Comment on SEC 2024-02

Eversource's SEC Exhibit 1 part [2/3](#) contains errors.

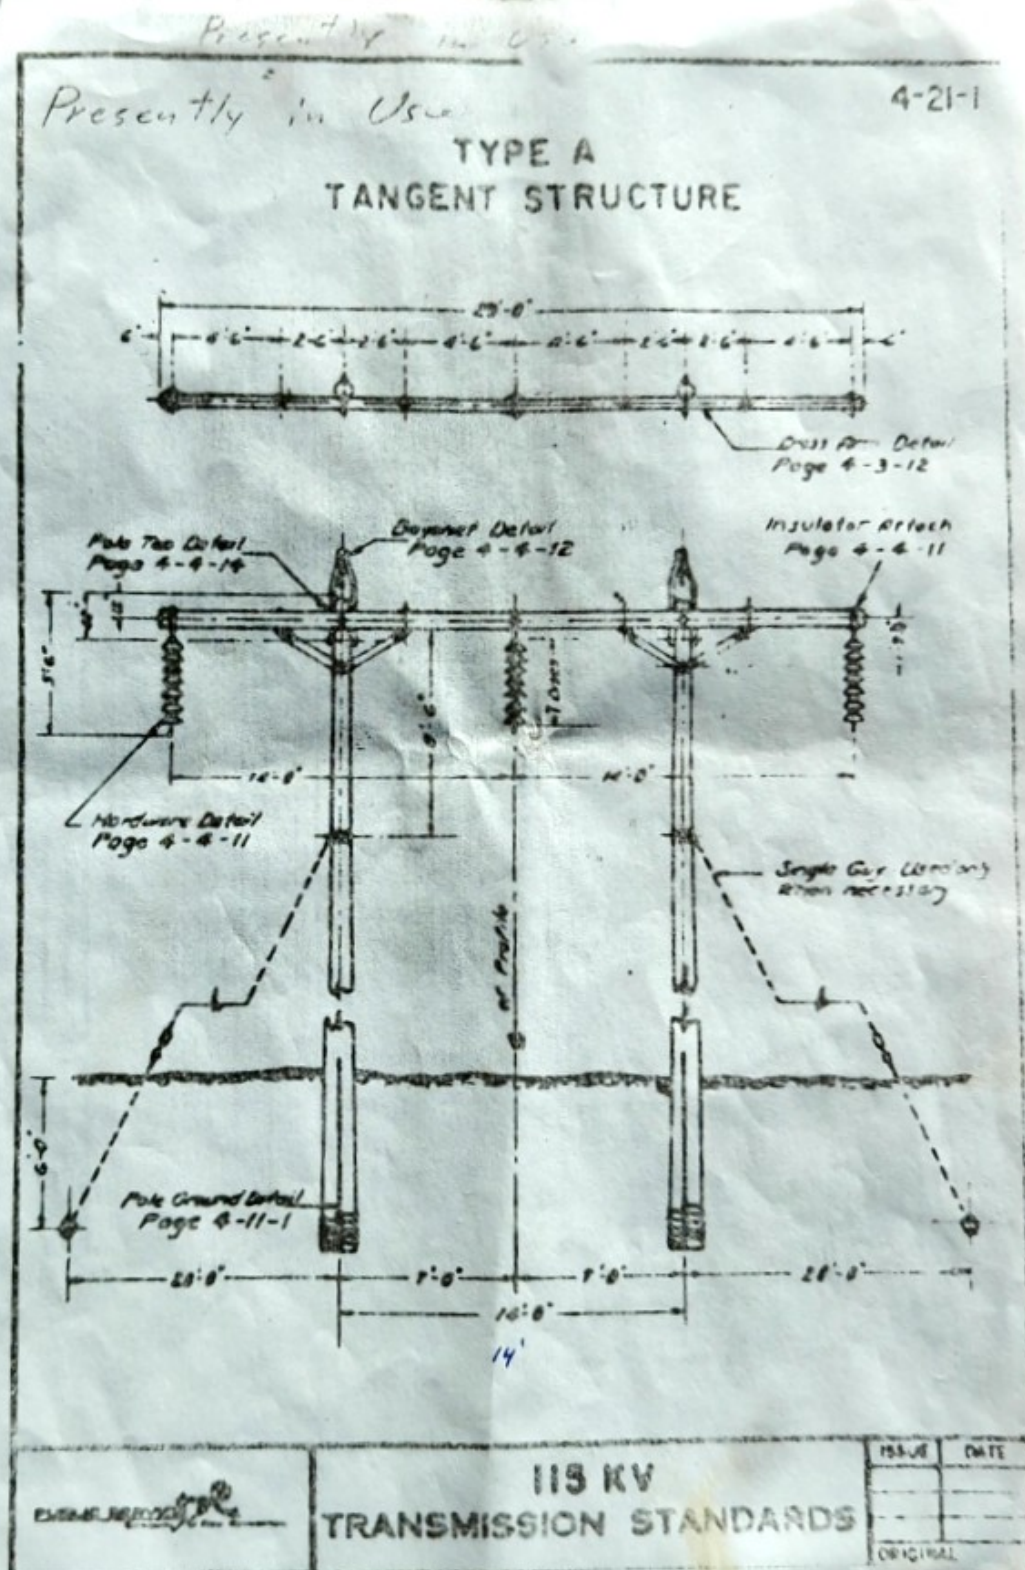
Eversource's Exhibit shows structures 1 through 407, which comprise the X-178 (1 & 2), as the 1948/1969 type structure shown below:

The actual X-178 (1 & 2) structures have larger poles, cross-bracing on most of the structures, different bracing above the cross-bar and different ground/static wire carriers.

Below: 1985 X-178 (1 & 2) structure:

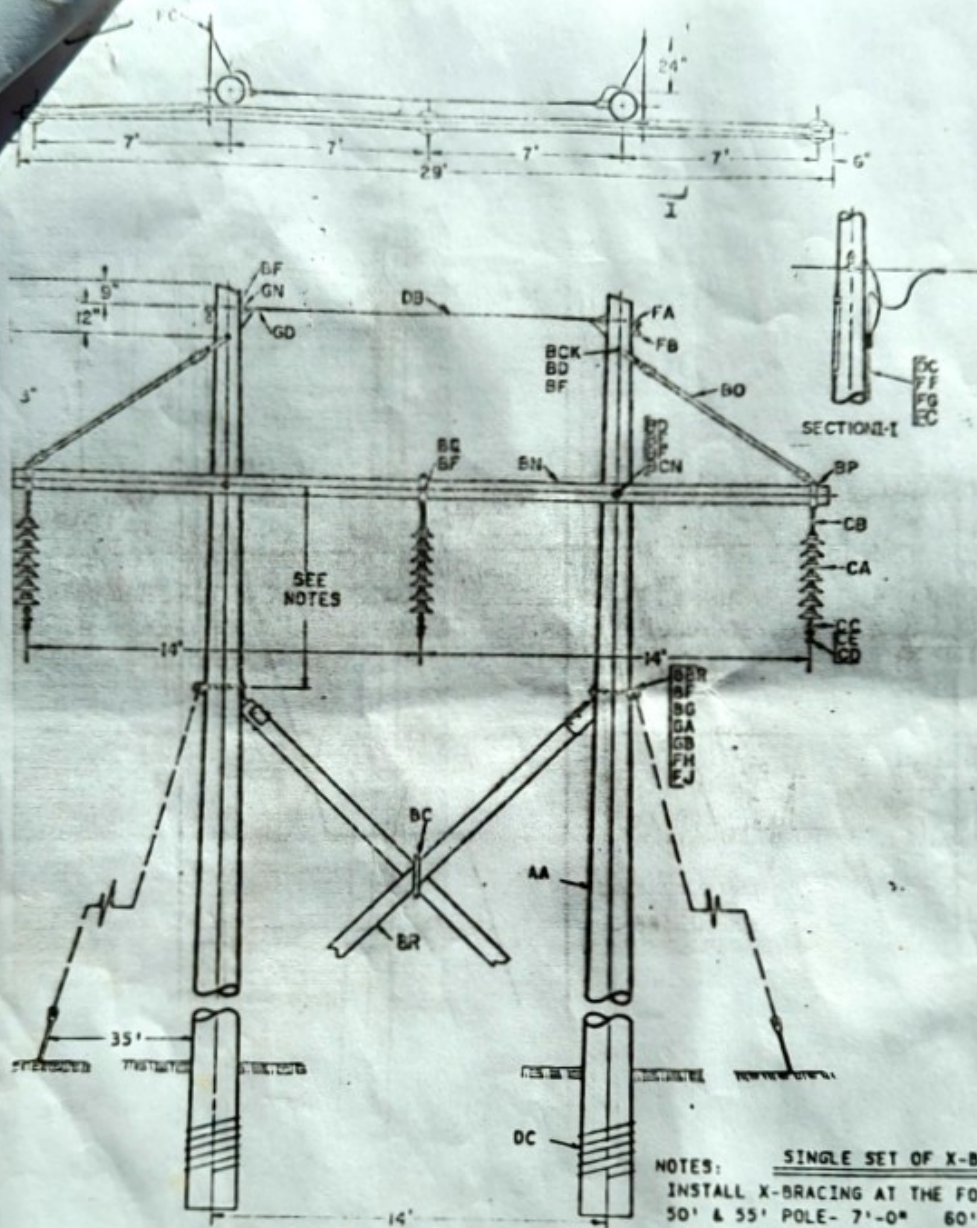
Third party ground-proofing and collection of information, including structure inspections, is necessary for the SEC to make informed decisions in this docket.
